DESIGN & CONSTRUCTION MANUAL DESIGN CRITERIA MODIFICATION REQUEST

PROJECT NAME: East Trails Middle School (LS 7 SD)

PERMIT NUMBER: PL2020259

DESIGN MODIFICATION REQUEST
EXHIBIT 1

EDD-1
EMERGENCY SPILLWAY DETAIL
(DESIGN VS AS-BUILT)

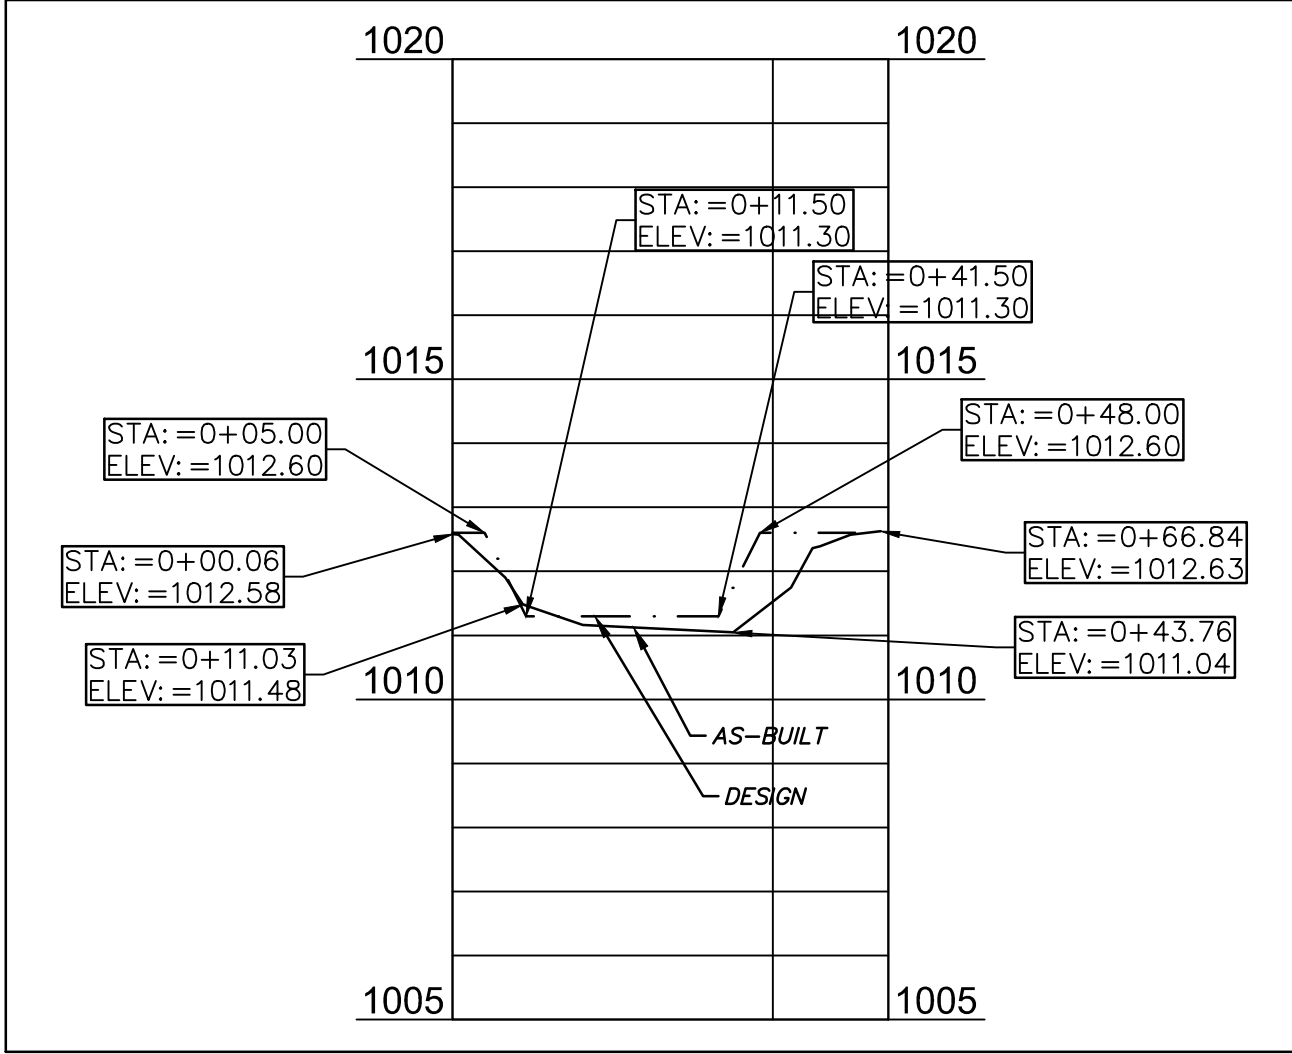
This waiver request is being requested on behalf of the Lee's Summit School District. The waiver request is in regard to the emergency spillway on the extended dry detention basin (EDD-1) on the East Trails Middle School Campus located at 1001 SE Bailey Road. As shown in the attached exhibit, an as-built survey was completed for the basin in August 2022. The survey showed a slight increase in pond volume. The 100-Year water surface was adjusted for this volume increase. The WSE went from 1010.80 to 1010.65. The survey also showed the crest for the emergency spillway had been constructed at 1011.04 (low point), instead of the design elevation of 1011.30. This results in a freeboard of 0.39'. This is 0.11' short of the freeboard requirement of 0.50' required per Section 5608.4F (KCAPWA). The spillway was constructed wider than the design requirement (32' actual length instead of the 28' design length).

A waiver is being requested because this deficiency will have no impact on the Levels of Service indicated in Section 5601.8 (KCAPWA). There will be no impact to public safety, adjoining properties or downstream conditions. The emergency spillway is only in use if the primary outlet is completely blocked and the basin is full. The emergency spillway also has the capacity to handle the 100-year flow in this event.

The basin is located adjacent to the stream buffer for the unnamed tributary located on the east side of the school property. Should the basin overflow, it will dump directly into the tributary, crossing no other properties. In a sudden release of impounded water, the spillway, as constructed, will control the overflow and protect the basin as defined in 5601.2 (KCAPWA).
